Straw Man Preferred Transportation Network
Issues Discussed by Task Force April 14 and 15
Further Discussion

Consultant Draft of Preferred Concept for Discussion with Task Force, April 14-15, 2008

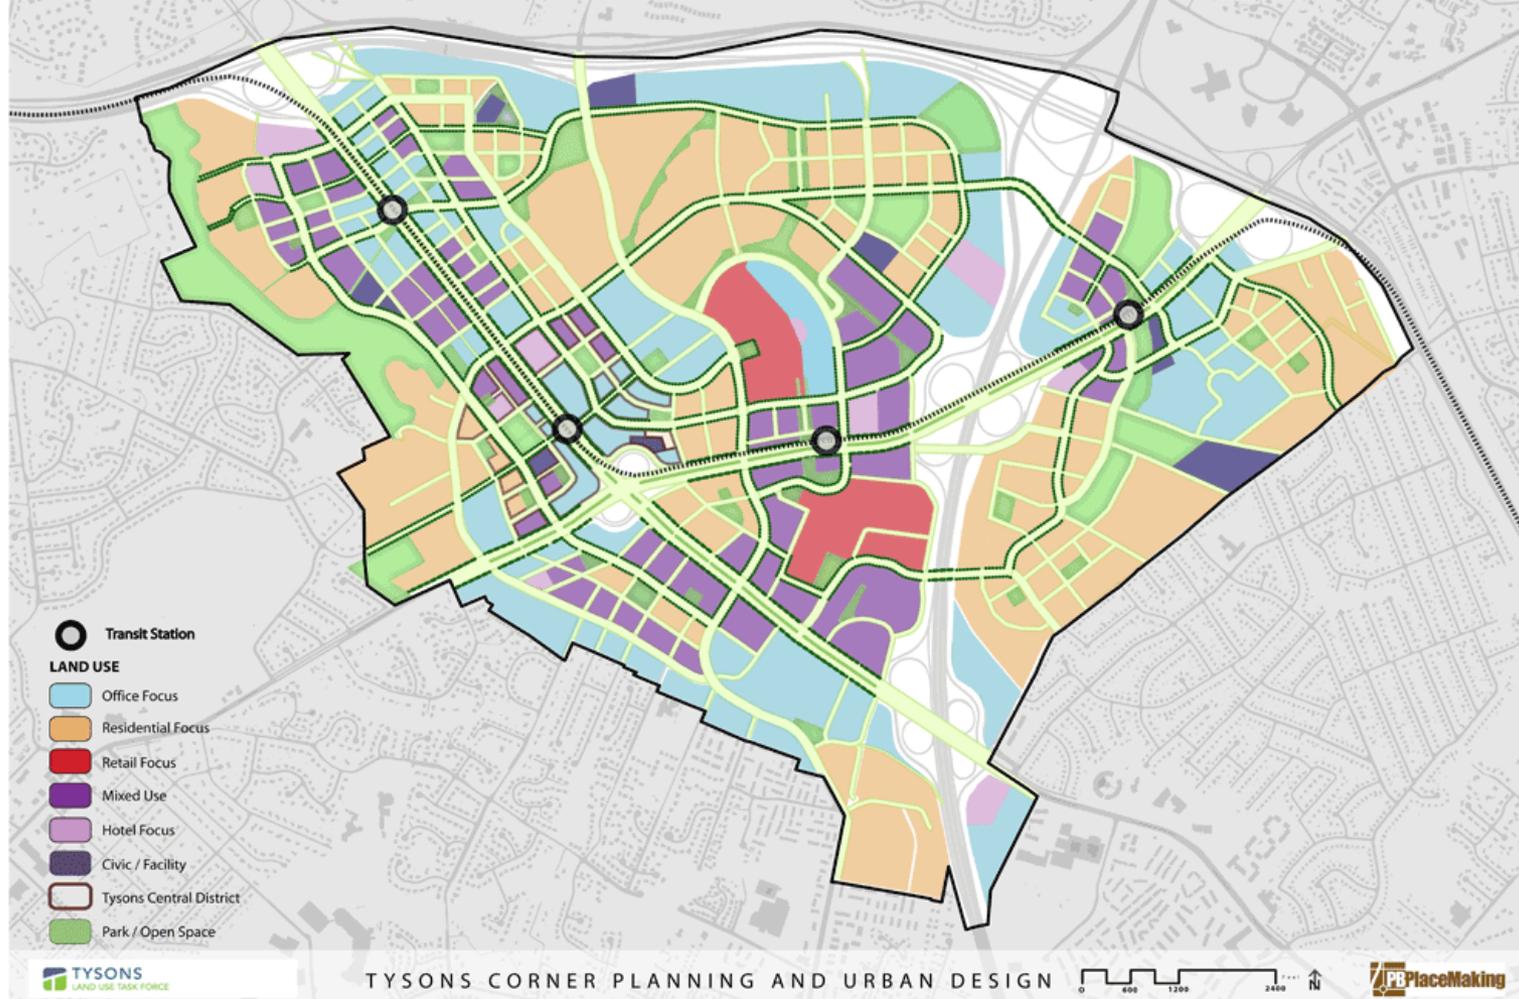
- Shopping Mall/Old Meadow (Special Purpose Overpass) (#3 in slides) – Is there consensus is to include this overpass?
- Highway Ramps
 - Greensboro Drive/Tyco Road to Dulles Toll Road (WB) (#2 in slides): Not recommended in Straw Man due to engineering considerations. Several task force members indicated that this ramp should be included in the preferred network.

- Boone Boulevard to Dulles Toll Road (WB) (#1 in slides): Not included in Straw Man due to engineering considerations. Conflicts would exist with Dulles Airport Access Road ramp and with rail structure. Several task force members indicated that this ramp should be included in the preferred network.

- As an alternate and or supplement to the ramps above, capacity and operational improvements to the Dulles Toll Road/Route 7 interchange and to the Dulles Toll Road/Spring Hill Road interchange (#3 in slides) should be investigated.

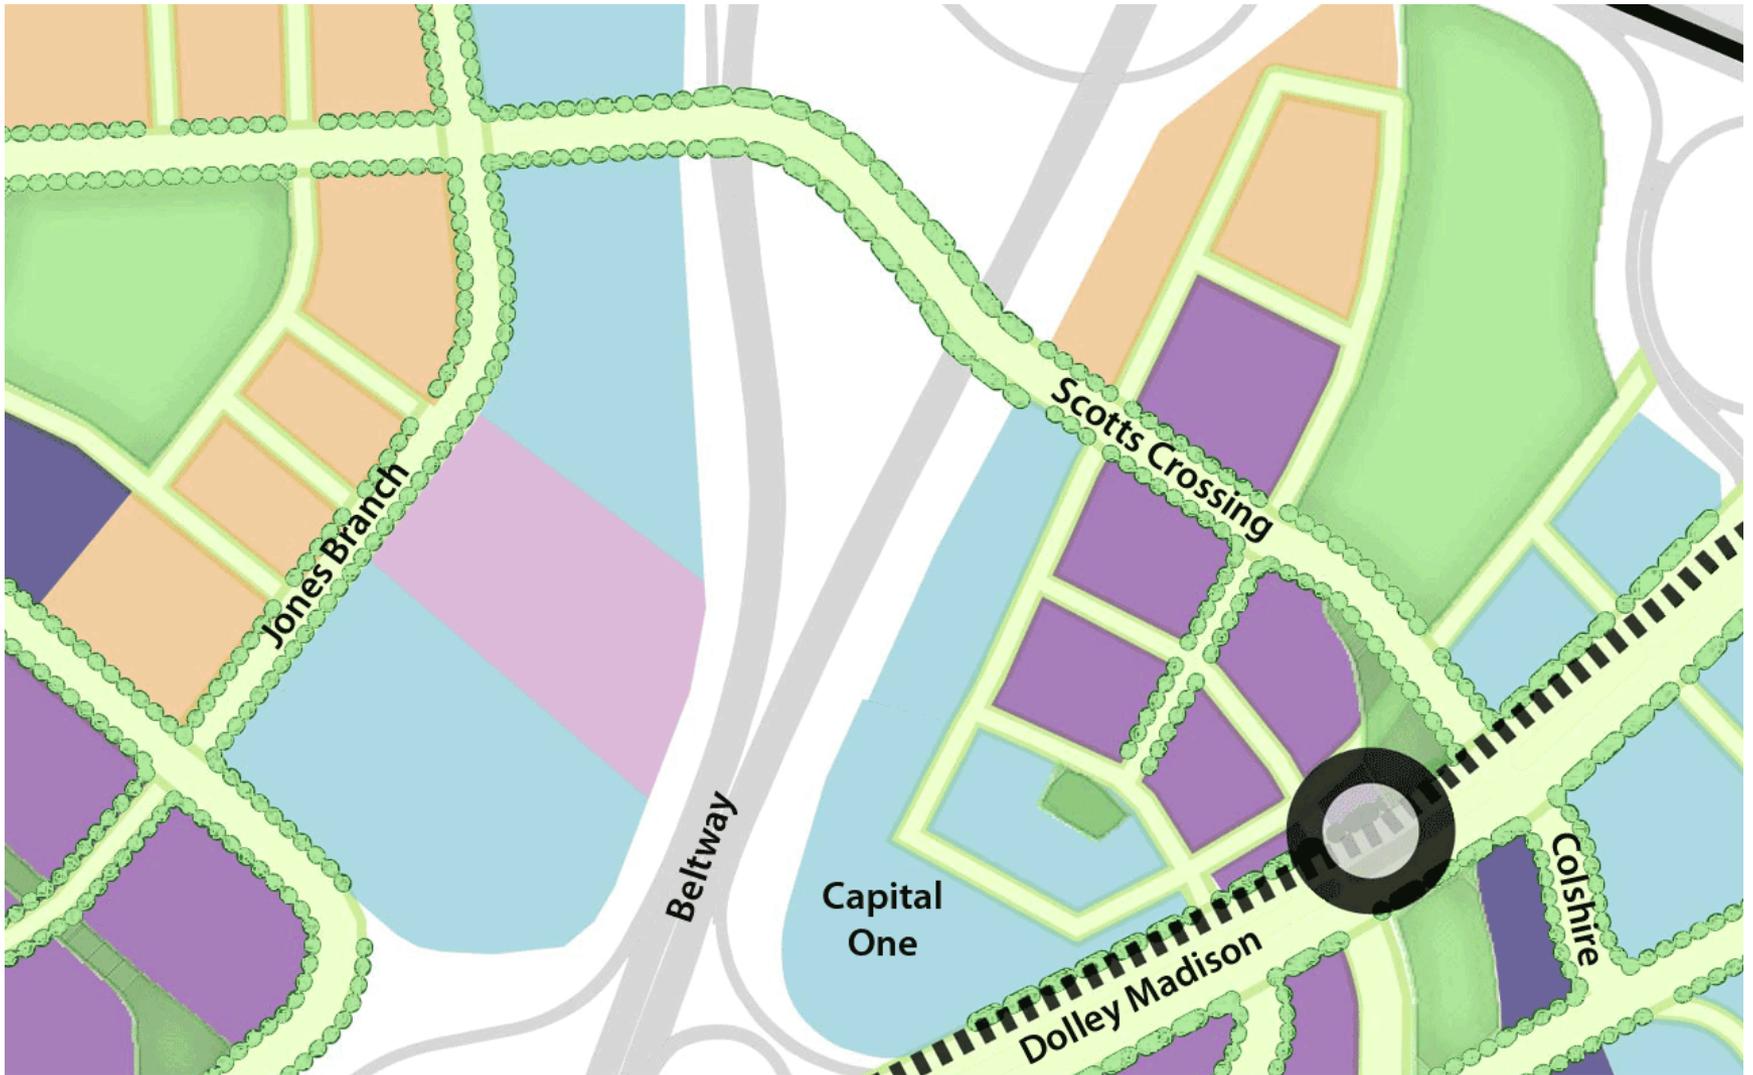
- Grade Separations
 - Route 7/Westpark Drive/Gosnell Road (included in current Comprehensive Plan): Not recommended in Straw Man. Some task force members suggested including this grade separation.
 - Route 7/International Drive (included in current Comprehensive Plan): Not recommended in Straw Man.
 - Route 123/International Drive (included in current Comprehensive Plan and recommended in Straw Man): Some questions were raised regarding constructability and pedestrian accommodations.
 - Route 123/Scotts Run Crossing/Colshire Drive: Not recommended in Straw Man due to impact on rail facilities (bus bays and kiss and ride area). Some task force members wanted to include this grade separation.
 - Route 123/Old Meadow Drive: Not recommended in Straw Man as cannot be constructed due to rail line elevation. Some task force members wanted to include this grade separation.

Beltway Crossing #1

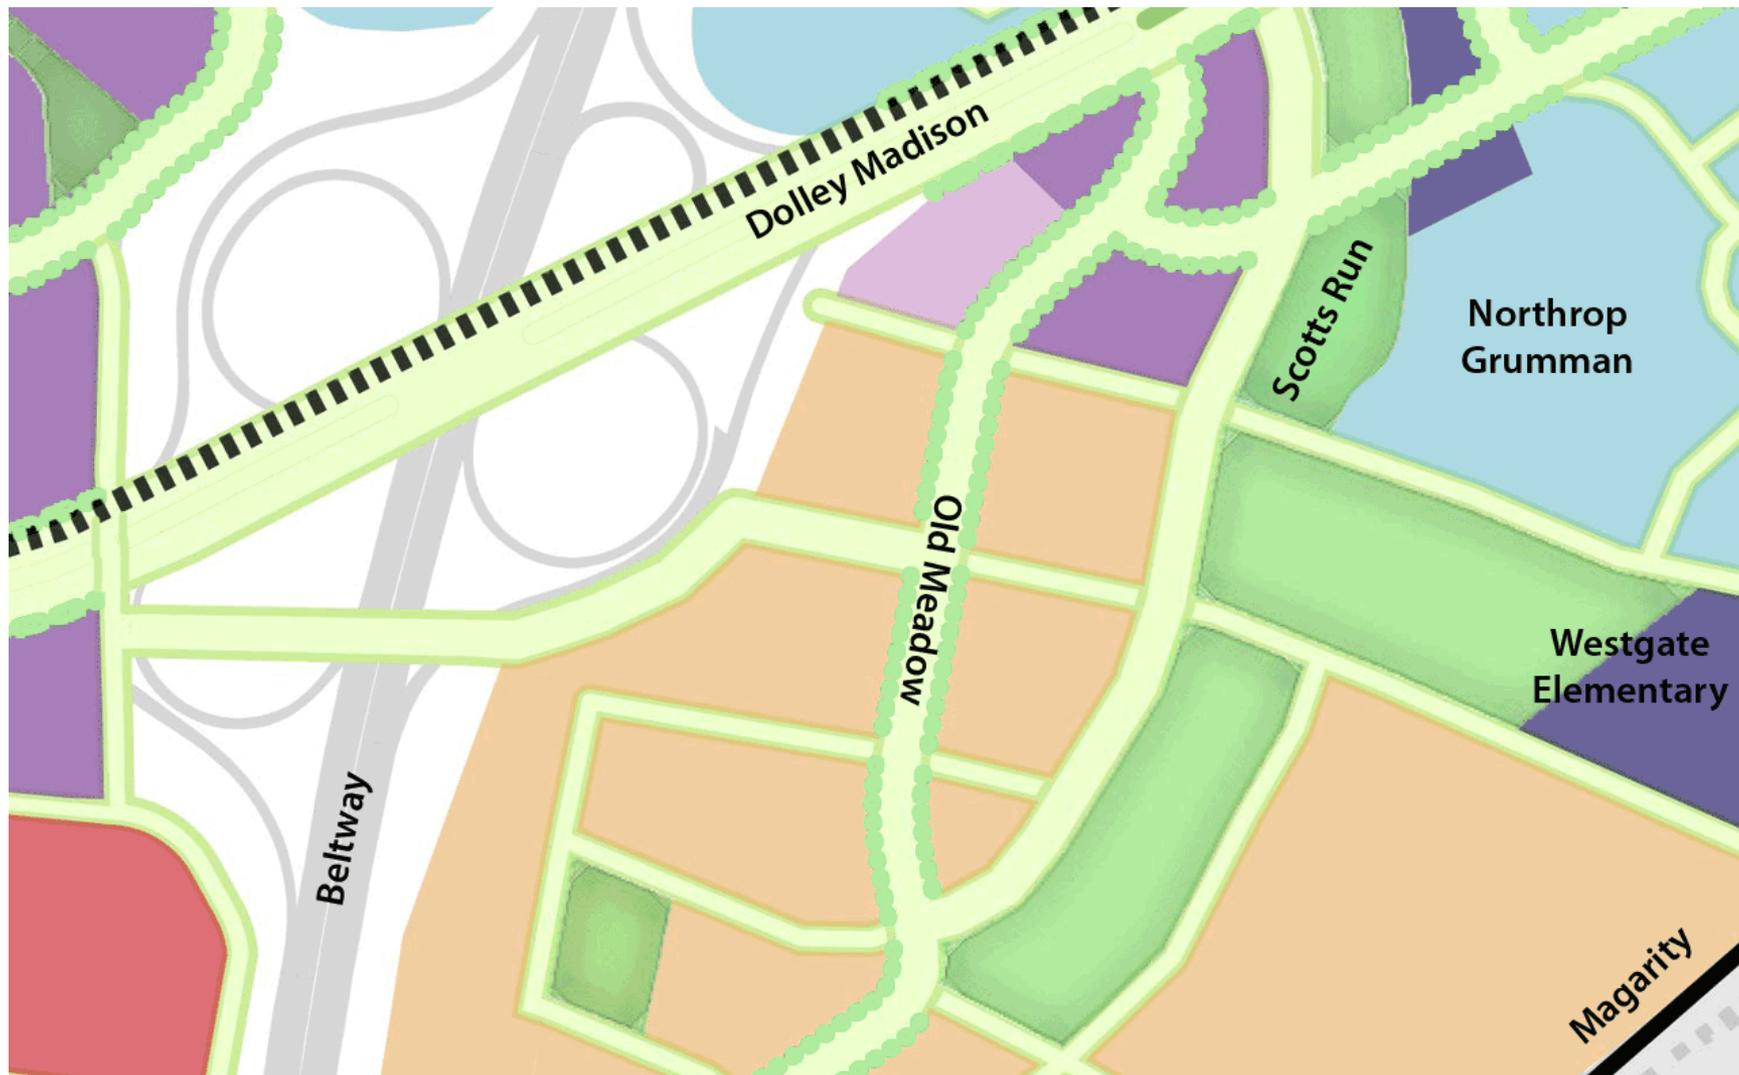
- Include bike lanes where appropriate.
- Beltway Crossings
 - Scotts Run Crossing(HOT) (#1 in slides) – consensus is to include this overpass
 - Route 123/Old Meadow Overpass (HOT) (#2 in slides) – Concerns raised about impact of this crossing on new neighborhood inside Beltway.
